FROM: Buke Power Co Charlotte, NC 28201 A C Thies		DATE OF DOC 10-31-74	DATE REC'D 11-8-74	LTR XXXX	TWX	RPT	OTHER
TO: Mr. Giambusso		ORIG one signed	CC	OTHER	SENT AEC PDR	xx	SENT LOCAL PDR
CLASS	UNCLASS XXXXXXXX	PROP INFO	INPUT	NO CYS REC'D 1	DOCKET NO: 50-269		
DESCRIPTION: Ltr submitting changes to their 9-20-74 request for change to tech specs.....				ENCLOSURES: ACKNOWLEDGED DO NOT REMOVE			
PLANT NAME: Oconee #1

Re: Oconee Unit 1
Docket No. 50-269

On September 20, 1974, Duke Power Company submitted proposed changes to the Oconee Nuclear Station Technical Specifications and the Babcock & Wilcox Report BAW-1409, "Oconee 1, Cycle 2 Reload Report," to support operation of Oconee 1, Cycle 2 at rated power.

REPLACEMENT PAGES FOR
PROPOSED TECHNICAL SPECIFICATIONS

Figure 3.5.2-1A1

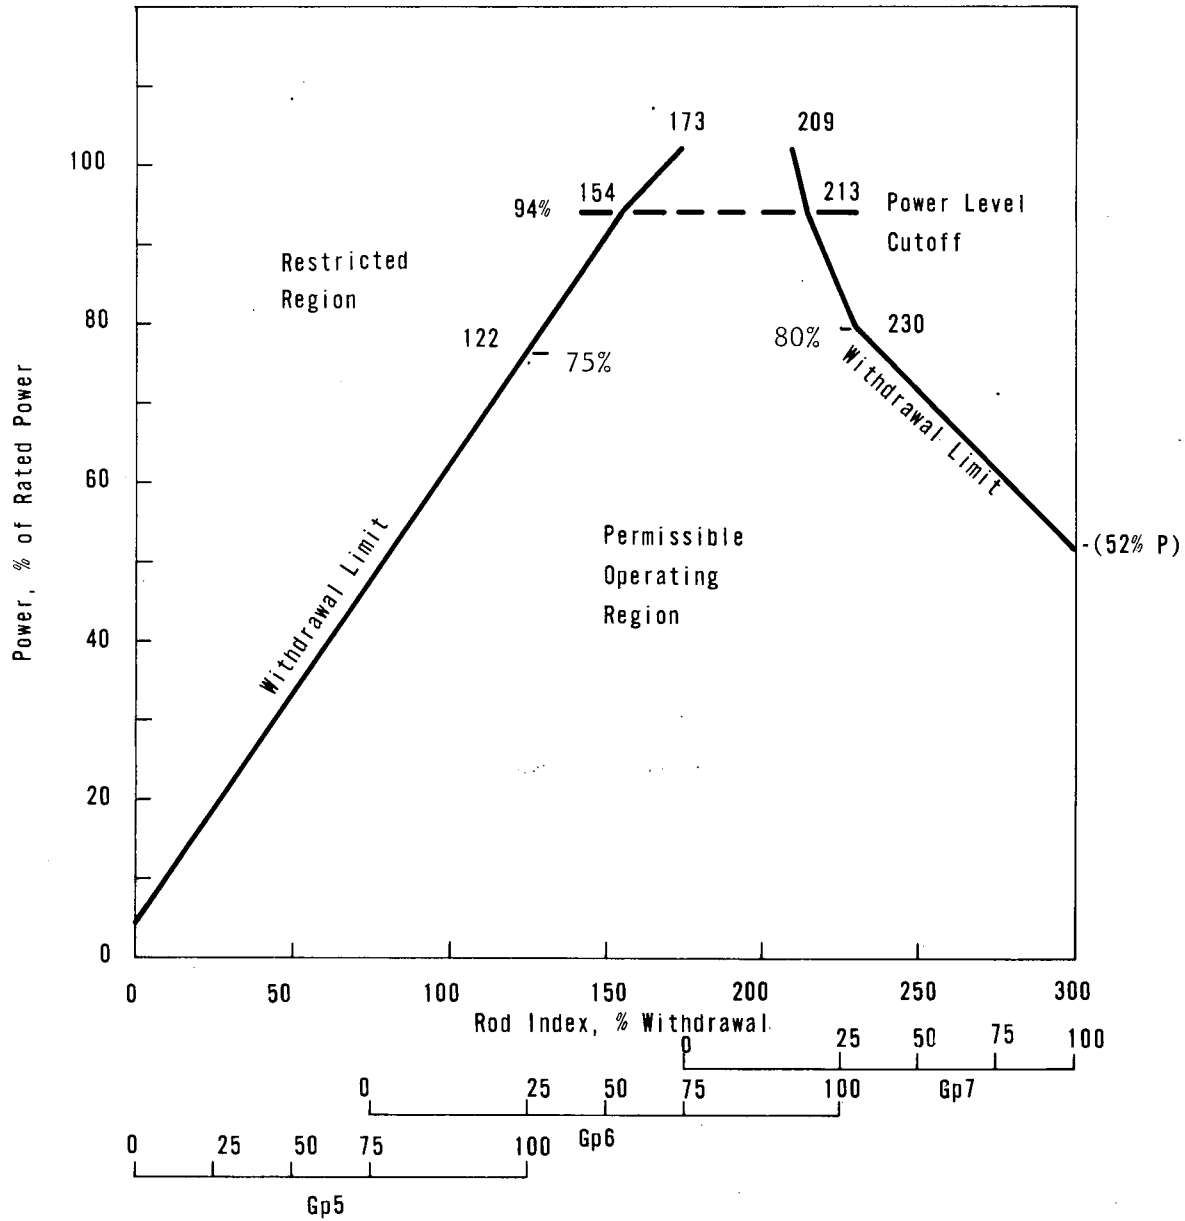
1. Figure 3.5.2-1A1 of proposed Technical Specification 3.5.2 satisfies both the Interim Acceptance Criteria and Appendix K to 10CFR50. This figure shows the control rod group withdrawal limits for four pump operation for the first 250 full power days of operation. Figure 3.5.2-1A2, which shows the withdrawal limits in effect after 250 full power days of operation, satisfies only Appendix K to 10CFR50. In the unlikely event that the B&W ECCS evaluation model is not approved prior to completion of 250 effective full power days of Cycle 2 operation (approximately August, 1975), Technical Specification 3.5.2 will be appropriately modified to meet both the Interim Acceptance Criteria and Appendix K.

1. Rod index is the percentage sum of the withdrawal of the operating groups.
2. The withdrawal limits are modified after 250 ± 5 full power days of operation.

CONTROL ROD GROUP WITHDRAWAL LIMITS FOR 4 PUMP OPERATION

Figure 3-5 Control Rod Group Withdrawal Limits for Four Pump Operation

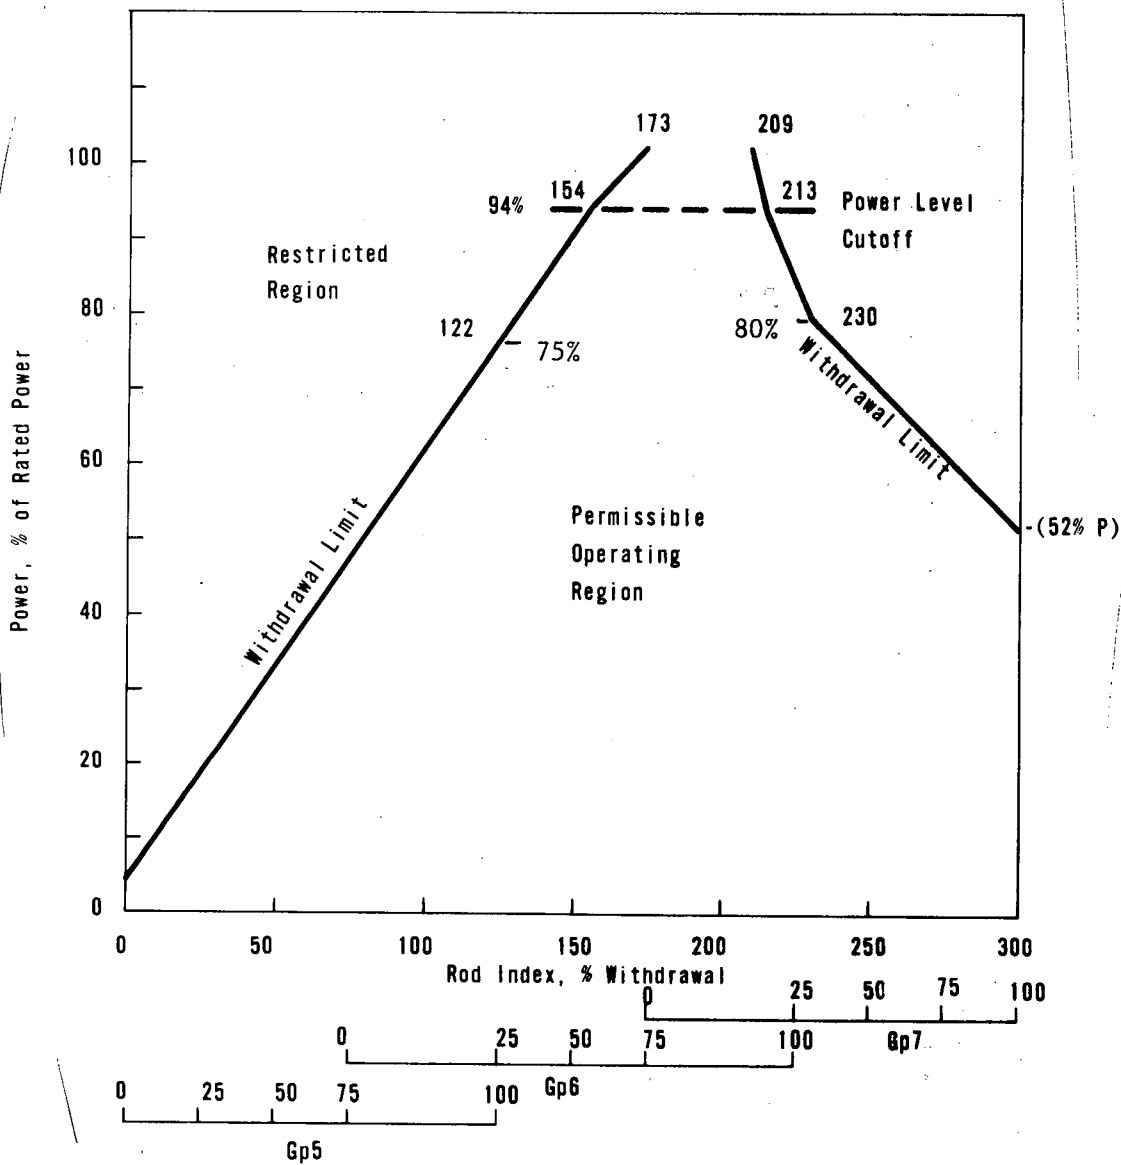
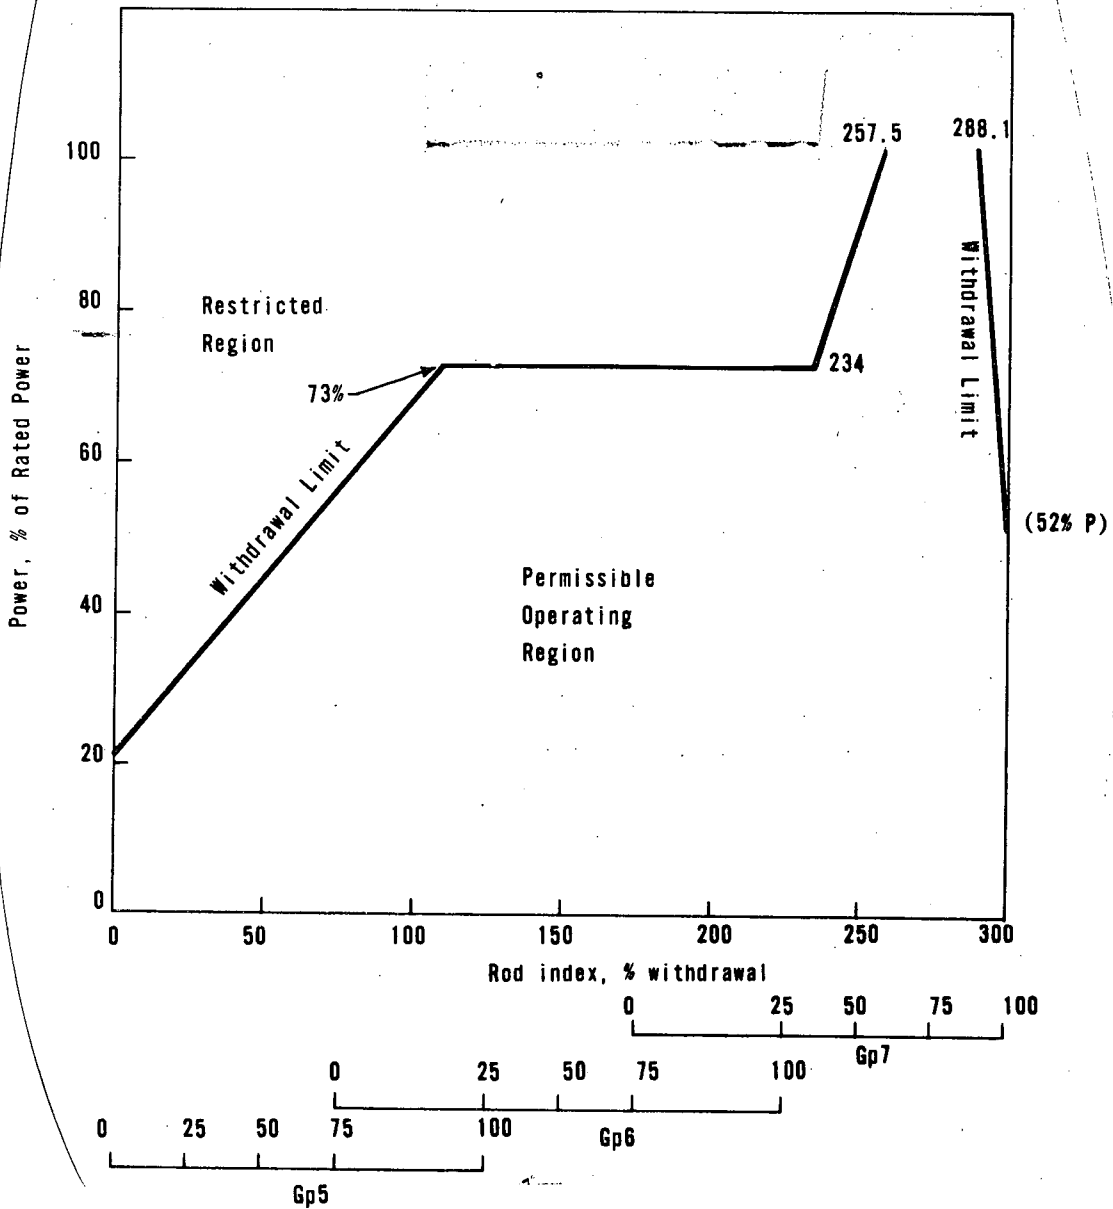
1. The maximum power peaks resulting from Cycle 2 operation occur in fresh (Batch 4) fuel assemblies throughout the cycle. The largest total power peak in the once-burned fuel is always at least 20 percent lower than the power peak in the fresh fuel. Thus, the effect on power peaking of burnup gradients across the once-burned assemblies is insignificant with regard to operational limits. The plant can operate at rated power without exceeding DNBR, fuel melt, and ECCS criteria by adhering to the limits specified in figures 3-3 through 3-7.

1. Rod index is the percentage sum of the withdrawal of the operating groups.
2. The withdrawal limits are modified after 250 ± 5 full power days of operation.

1. Rod Index is the percentage sum of the withdrawal of the operating groups.
2. The withdrawal limits are in effect after 250 ± 5 full power days of operation. (The applicable power level cutoff is 100% power)
